Technical design note

Project name	Himley Village, Bicester - Reserved Matters Application		
Design note title	Response to LLFA Comments		
Document reference	27141-HYD-XX-XX-TN-C-0002		
Author	R Austin		
Revision	P01		
Date	22 March 2023	Approved	☐

The following Technical Note is to be read in response to LLFAs comments on the Reserved Matters application reference 23/00207/DISC regarding the surface water drainage strategy for the Proposed Himley Village development site.

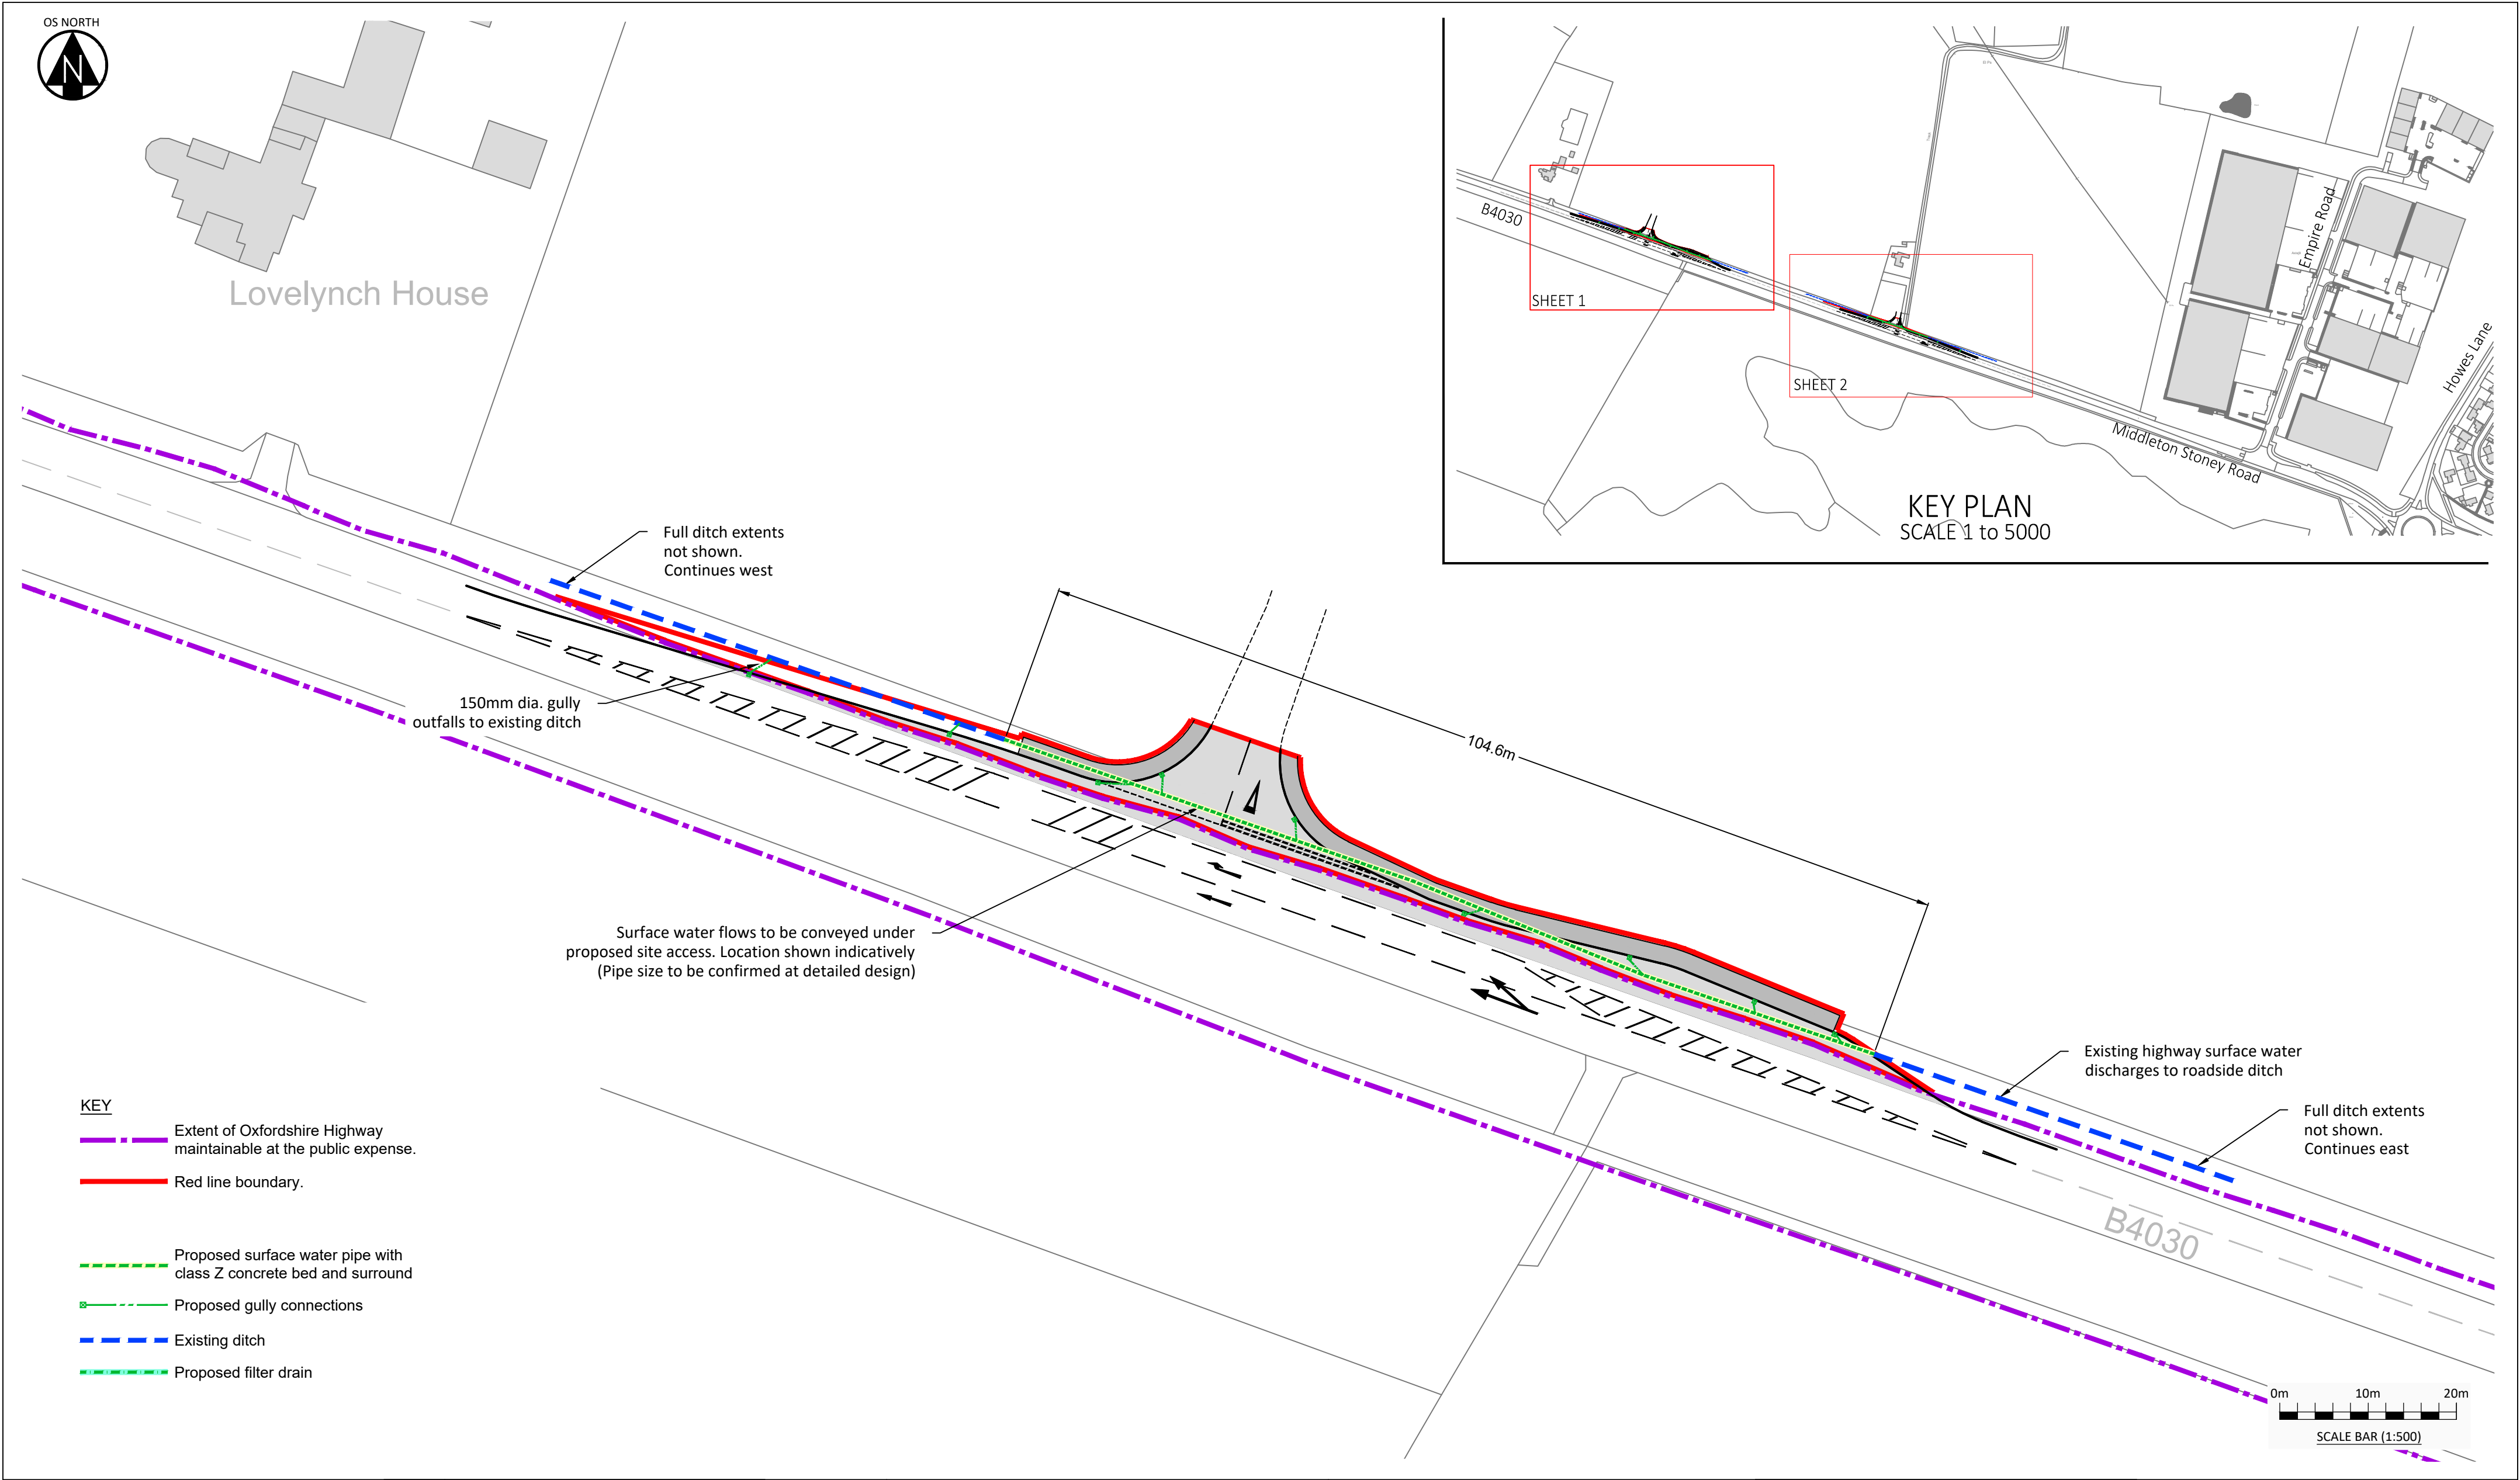
Detailed drainage plan not provided to illustrate the SuDS features

Drainage plans for each access are appended to this technical note, there are no specific SuDS features in this application which is solely for 2x highway access points, the ditches proposed for use are existing.

TITLE
MIDDLETON STONEY ROAD,
SECONDARY ROAD JUNCTION.
PROPOSED DRAINAGE
SHEET 2

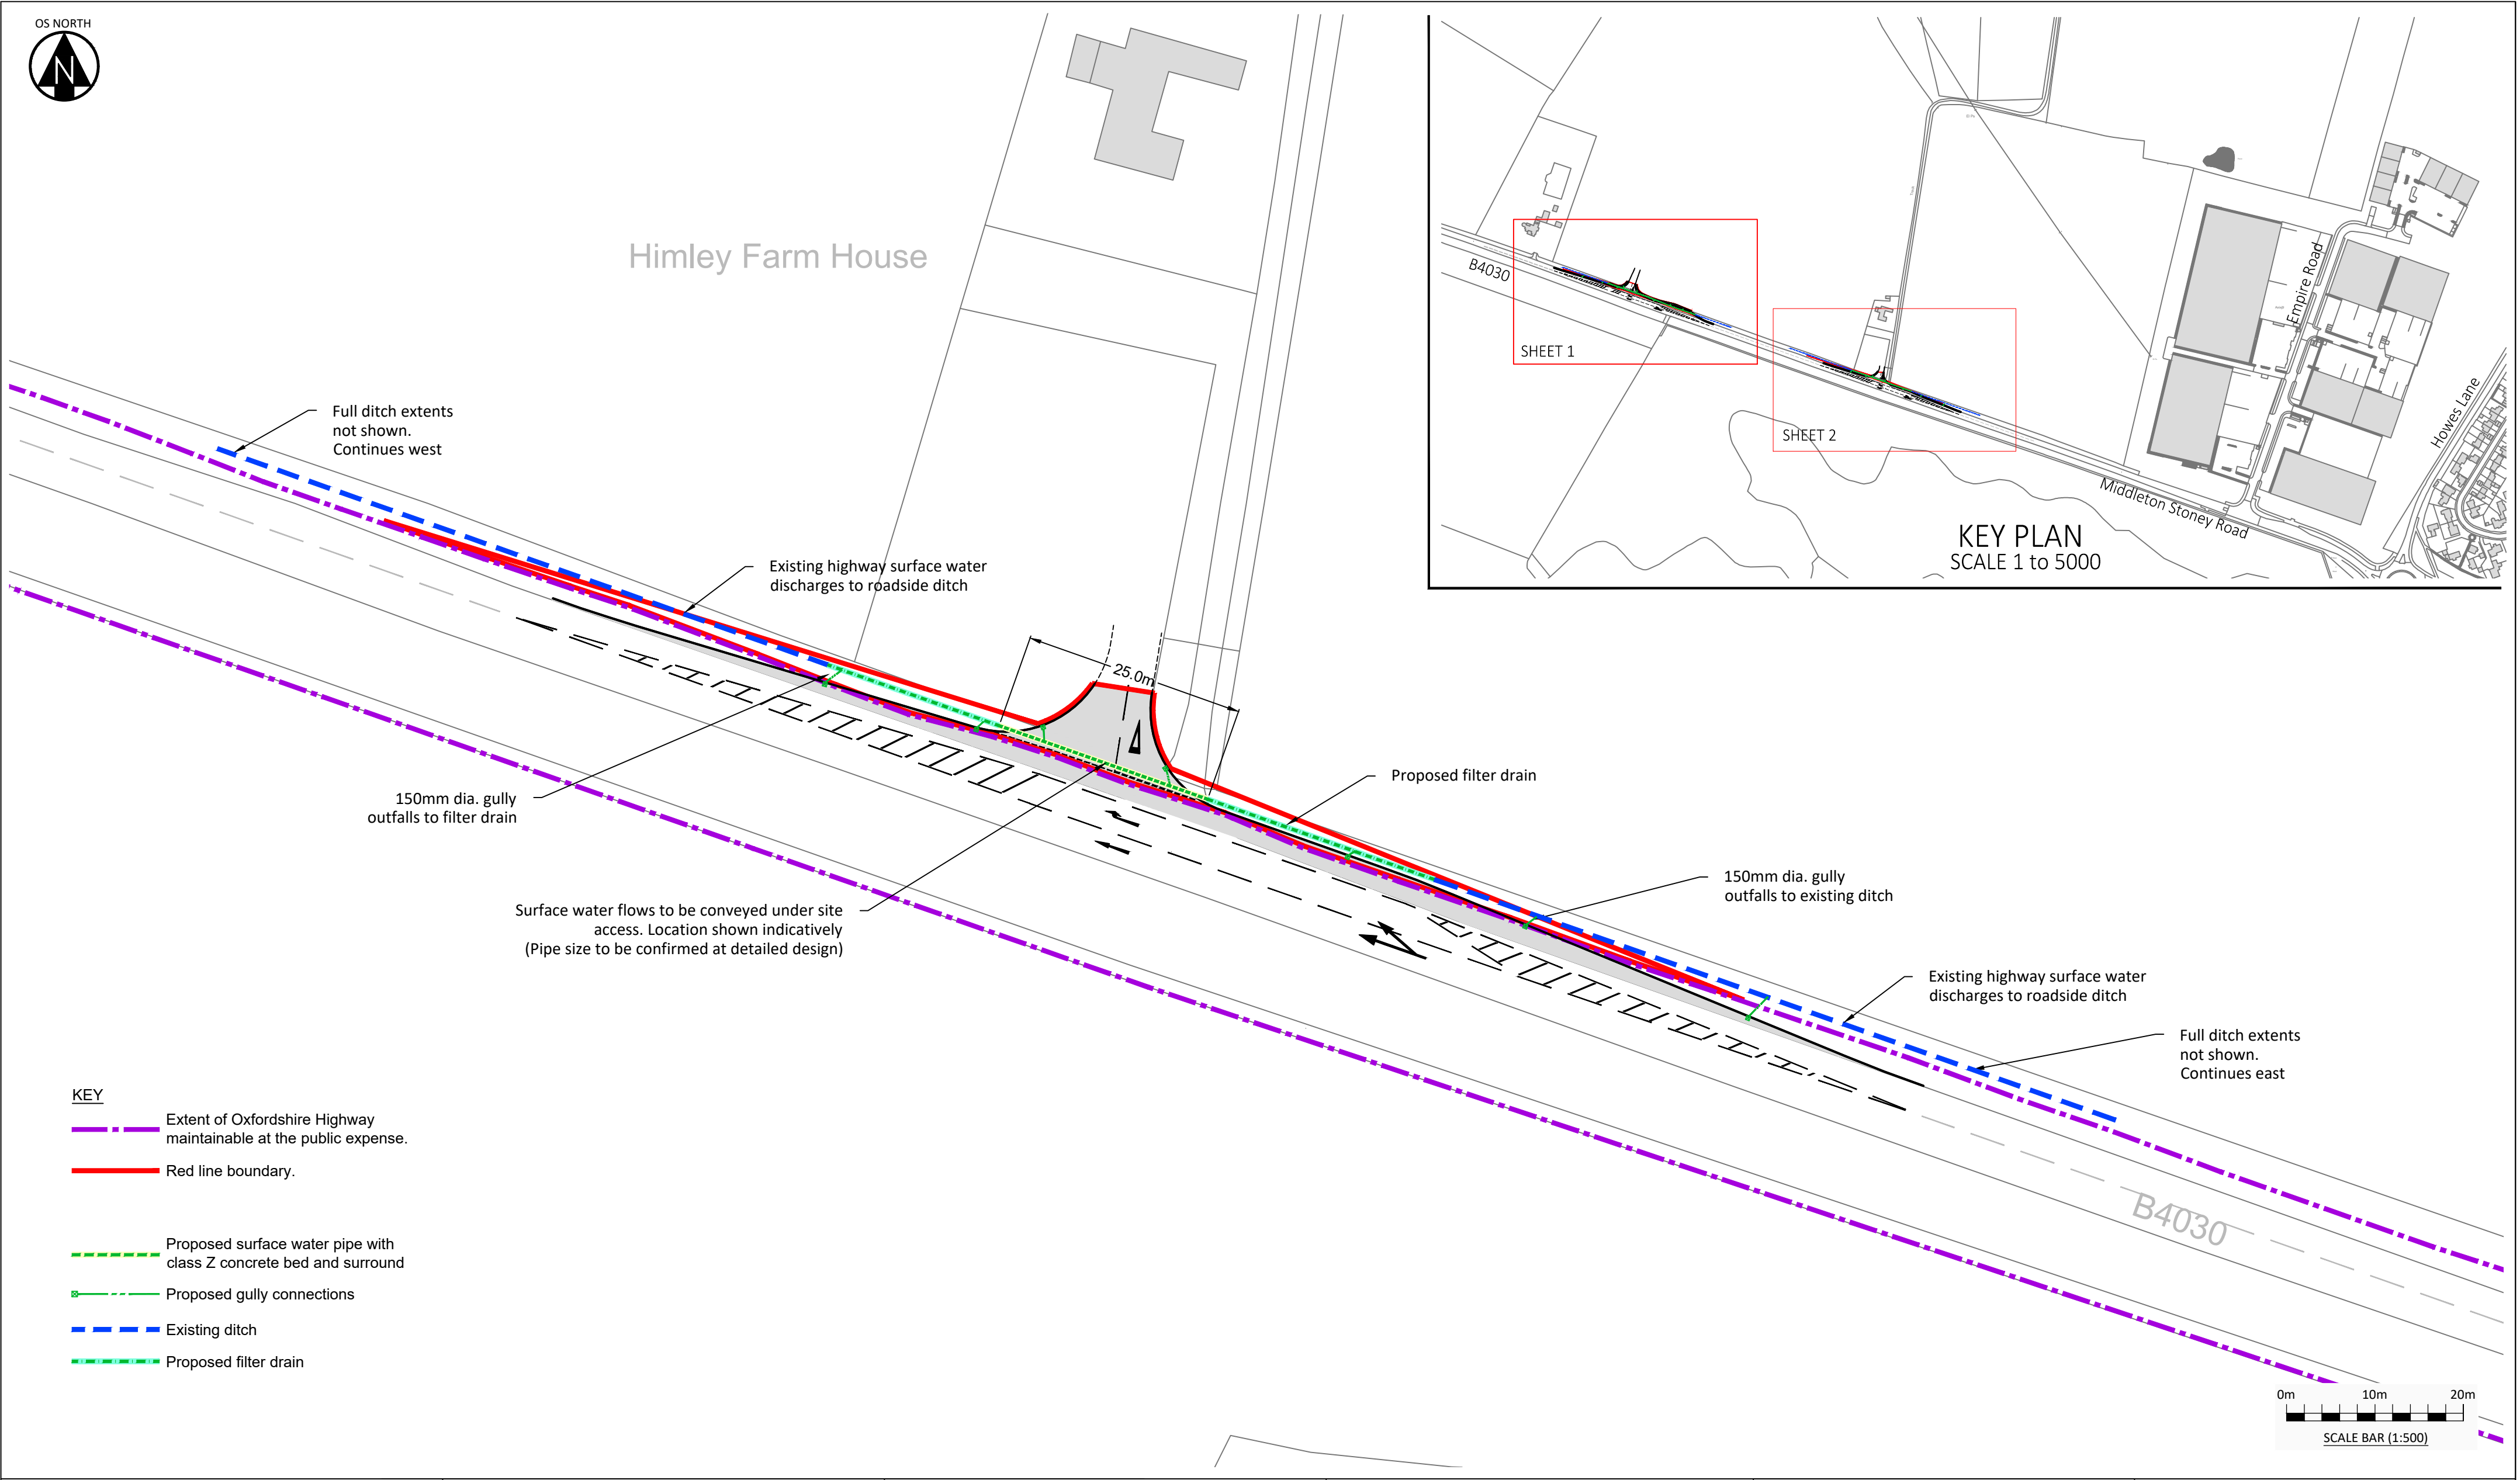
Discharge rates not provided on a drainage plan for each outfall location. Drainage plan not provided.

Discharge rates not provided on a drainage plan for each outfall location. Drainage plan not provided.

Drainage plans for each access are appended to this technical note, there is no specific network or "outfall" as such, each gully connect directly into the ditch adjacent (or culverted ditch if appropriate) and with each gully serving no more than 140m², a 20mm/hr rainfall event would see outfall rates from each gully at a maximum of 0.77l/s.
